# City of Santa Fe, New Mexico

# memo

**2025-010495-HDRB**, 439 Camino del Monte Sol Lot 1-A, Downtown & Eastside Historic District, Significant, Hoopes Architects, agent for Chris Greulich and Mathew Boland, owners, request approval to construct a 504 sq. ft. detached garage to a height of 10'-3" where the max allowable is 14'-0".

Figure 5. Proposed Floor Plan.

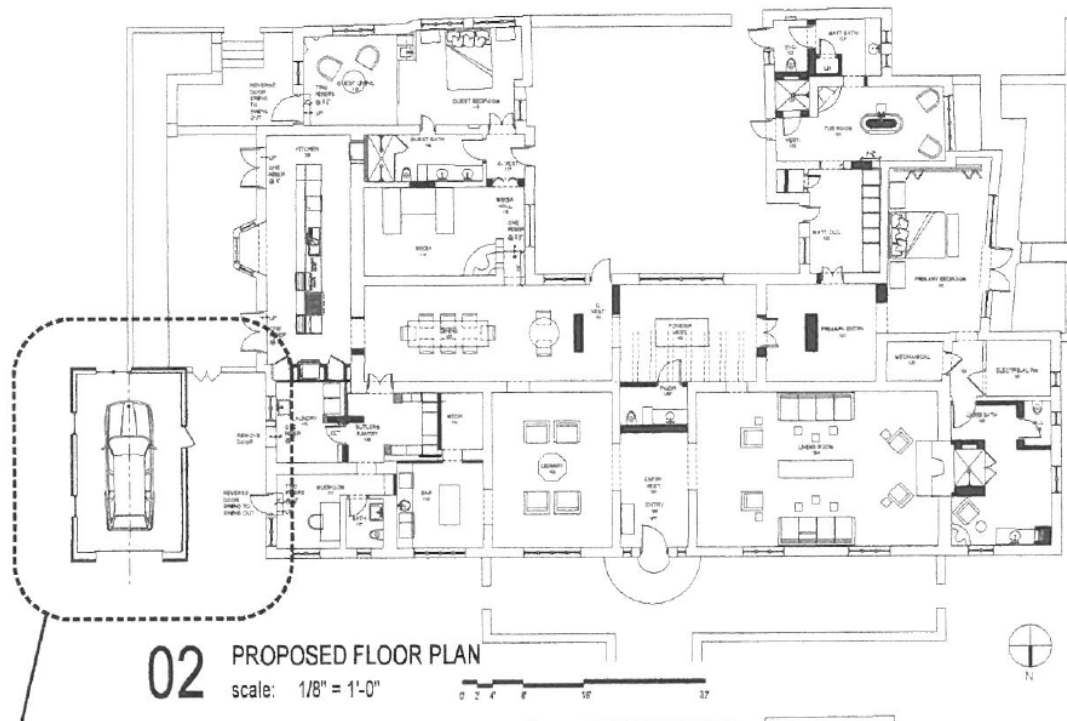
- 1) Construct a detached one-car garage on the east elevation to a height of 10'-3" where the maximum allowable is 14'.

Staff recommends approval of the proposed project and finds that the application complies with Section 14-5.2(D) General Design Standards for all Historic Districts, and 14-5.2(E) Downtown and Eastside Design Standards.
